SERVICE BULLETIN

Service Bulletin No.: DA20-33-02, Rev. 0

Title: Instrument Lighting,
Dimming Circuit for KLX135 or KLX135A GPS/COM

Figure 1. Ref. DAI Engineering Drawing #20-3910-01-00, rev. f

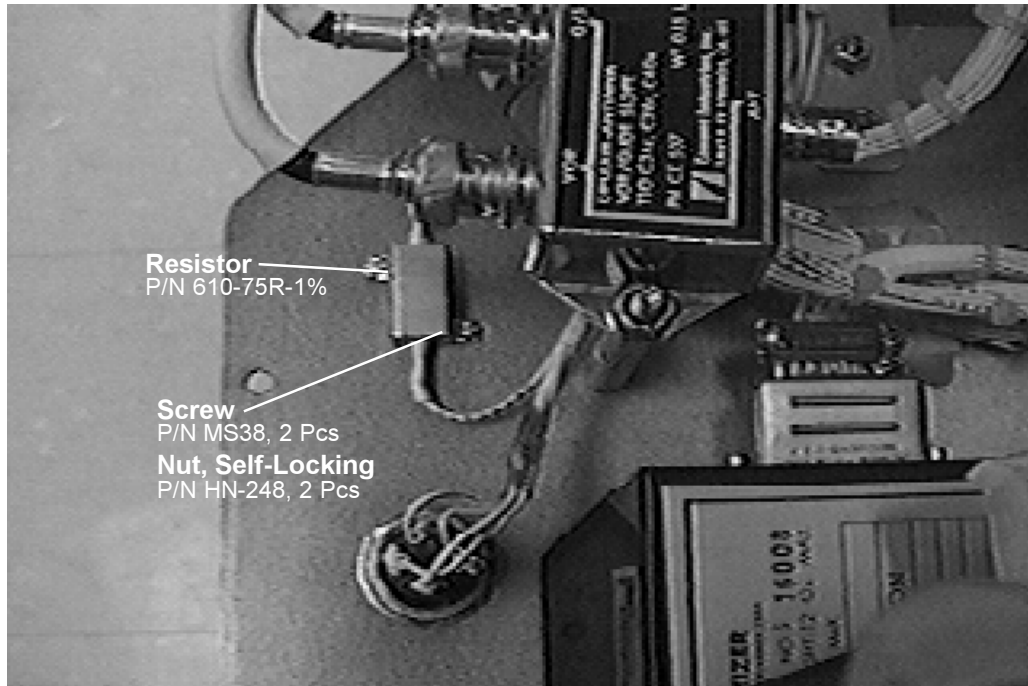
- 10.1 Remove cowlings and **Disconnect the negative lead from the battery.**
- 10.2 Remove the instrument panel cover.
- 10.3 Locate the resistor (ref. item 1), layout and drill holes as per figures 1 and 2.
- 10.4 Remove the trim display. Cut wires # 27511A22 and # 27512A22 approximately 1" behind the switch. Strip 1/4" of insulation from the wires.

- 10.6 Route wire #34736A22 and #34734A22 along the existing wire bundles to the resistor (ref. item 1) mounting location.
- 10.7 Mount the resistor (ref. item 1) as shown in figure 1.

Figure 3. Ref. DAI Engineering Drawing #20-2400-99-00, rev. d

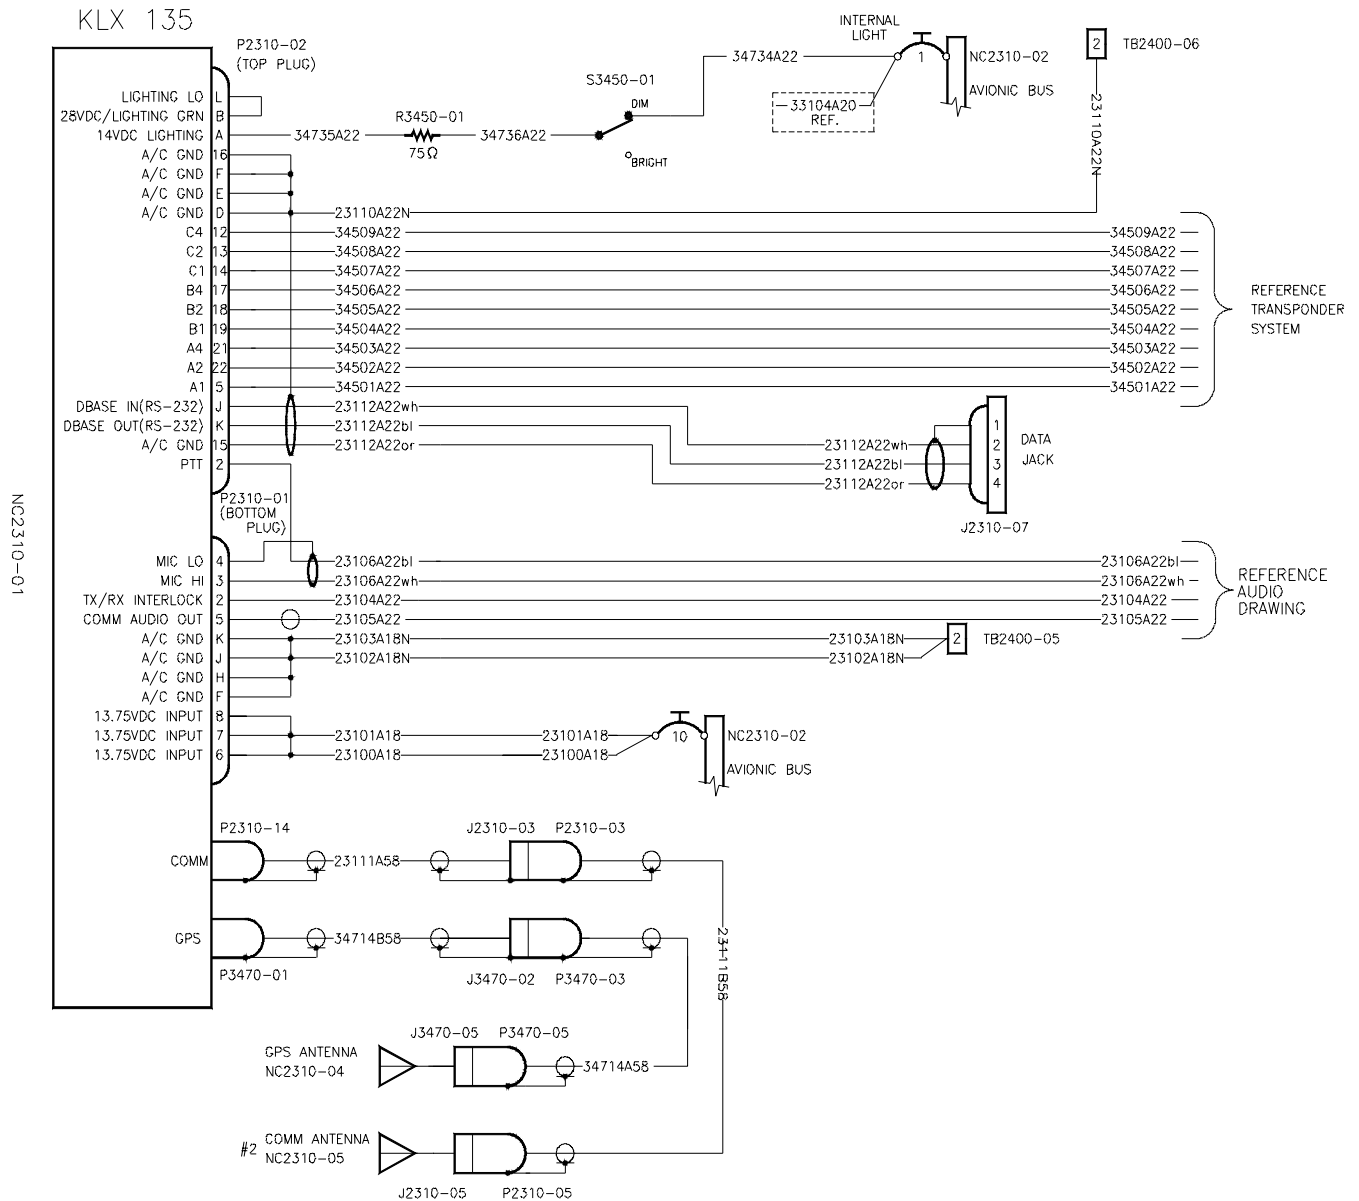
8. **Special Tools:** None
9. **References:** Figure 1, Figure 2, Figure 3, wiring diagram 20-2400-99-00 sheet 3.
